This letter serves as notification to the U.S. Department of Transportation, National Highway Traffic Safety Administration by Dorel China America, Inc. (DCA) that a noncompliance with Federal Motor Vehicle Safety Standard 49 CFR 571.213 (FMVSS 213) S5.5 labeling requirements exists on certain babidéalTM Storm Booster Child Restraint Systems (CRS). DCA determined that this noncompliance existed on this motor vehicle equipment on October 9, 2019.

The babidéal™ Storm Booster CRS is a backless belt positioning booster CRS with a multi-colored triangle pattern textile cover. Intended for use by children 40-100 lbs. and 43"-57" in height. The recalled lot of products were sold exclusively at Family Dollar Stores in the United States. See product image below.

See image below of the warning label location on the product.

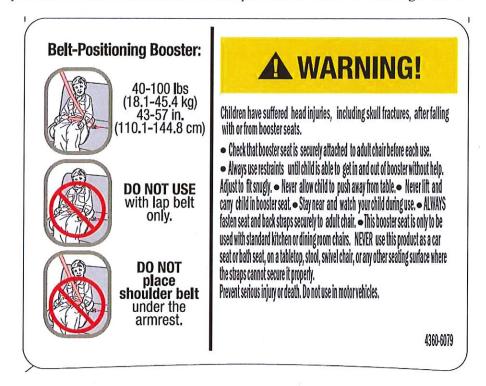
The contract manufacturer that produces the babidéalTM Storm Booster CRS for DCA was incorrectly provided warning label artwork that is noncompliant with FMVSS 213, which was then used in production on the specific lot being recalled. All other lots of the babidéalTM Storm Booster CRS were produced with a compliant warning label and were imported and sold using different model numbers to a different retailer.

The noncompliant label found on the recalled lot of products is shown in the image below.

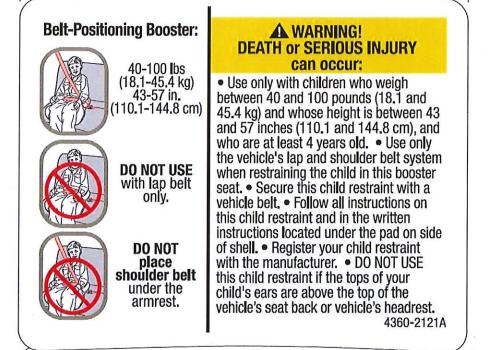
DCA has determined that 28,800 units of the babidéal™ Storm Booster CRS have been manufactured with a warning label that is not compliant with FMVSS 213. The recalled lot of products were sold

Because the safety warnings and instructions required by FMVSS 213 are not provided, caregivers do not have the benefit of that information and could potentially use the CRS inappropriately. Another risk is that the caregiver will be confused by the warning language (which comes from ASTM F2640 for use on indoor booster seats such as might be used in a dining room), because the incorrectly provided warning language states "NEVER use this product as a car seat..." and "Do not use in motor vehicles." For those consumers who are continuing to use the booster seat in a motor vehicle, DCA confirms that the product will perform appropriately and as intended because it remains compliant with all other performance requirements of FMVSS 213.

The label that is present on all other lots of the babidéalTM Storm Booster CRS which complies with FMVSS 213 and will be present on the free replacement fabric pads which will be sent to owners and purchasers as the recall remedy is shown in the image below.
